Access Compliance Report Public Rights-of-Way (Curb Ramps)

Main Street: HARVEST_LN		Cross Street: MYSTIC_LN		Location:	S
ADA ID: RPRK210927152035	Ramp Type: Type 1 - Perpendicular	Initial Pass/Fail: Pass	Overall Compliance: No	Severity Score:	18

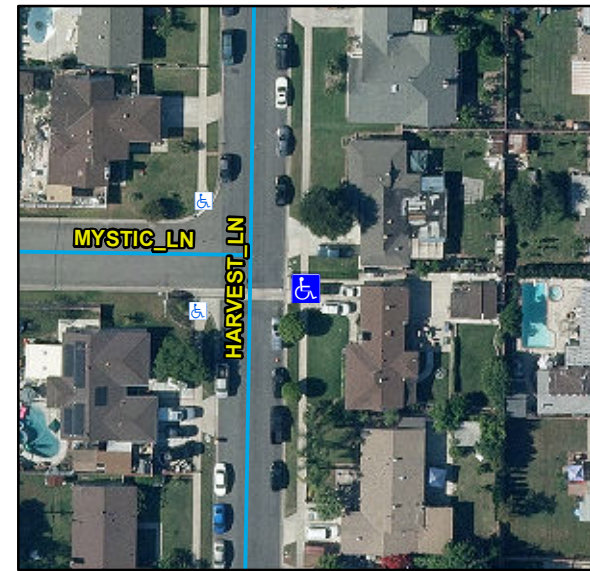
Compliance	Description	Data	Compliance	Description	Data
N/A	Ramp Length (in)	86	N/A	Flare Type LT	
Yes	Ramp Width (in)	100			Sloped
Yes	Ramp Run Slope (%)	7.3	N/A	Flare Slope LT (%)	5.4
Yes	Ramp Cross Slope (%)	2.3	N/A	Flare Traversable LT	No
N/A	Landing Present	Yes	N/A	Flare Type RT	
N/A	Landing Length (in)	47			Sloped
Yes	Landing Width (in)	110	N/A	Flare Slope RT (%)	5.4
Yes	Landing Run Slope (%)	0.3	N/A	Flare Traversable RT	No
No	Landing Cross Slope (%)	2.4	No	DWS Provided	No
N/A	Landing Movement Obstructed?	No	N/A	DWS Contrast	N/A
	Landing Movement Type	N/A	N/A	DWS Length (in)	N/A
N/A	Landing Shared	Yes	N/A	DWS Full Width	N/A
N/A	Clear Space	N/A	N/A	DWS Offset Left (in)	N/A
N/A	Clear Space To Crosswalk (in)	N/A	N/A	DWS Offset Right (in)	N/A
N/A	Marked Crosswalk 1	No	N/A	Marked Crosswalk 2	N/A
	Crossing 1 Direction	W		Crossing 2 Direction	N/A
	Marked Crosswalk 1 Width (in)	N/A		Marked Crosswalk 2 Width (in)	N/A

N/A	Ramp Inside Crosswalk 1	N/A	Yes	Ramp Inside Crosswalk 2	N/A
	Crossing 1 Slope (%)	1.4		Crossing 2 Slope (%)	N/A
	Crossing 1 Cross Slope (%)	2.9		Crossing 2 Cross Slope (%)	N/A
No	Gutter Ponding	Yes	Yes	Curb Slope	1.9
No	Gutter Lip Height (in)	0.5		Road Run Slope (%)	N/A
Yes	Gutter Run Slope (%)	0.1		Road Cross Slope (%)	N/A
Yes	Gutter Cross Slope (%)	1.2			
Yes	Overall Surface Condition: Acceptable		No	Perp Joint Present	No
	Cross Gutter Present?	Yes		Spandrel Present?	No
	Replace Cross Gutter?	No		Replace Spandrel?	N/A

Remove & Replace Entire Ramp. Grind Gutter Lip.
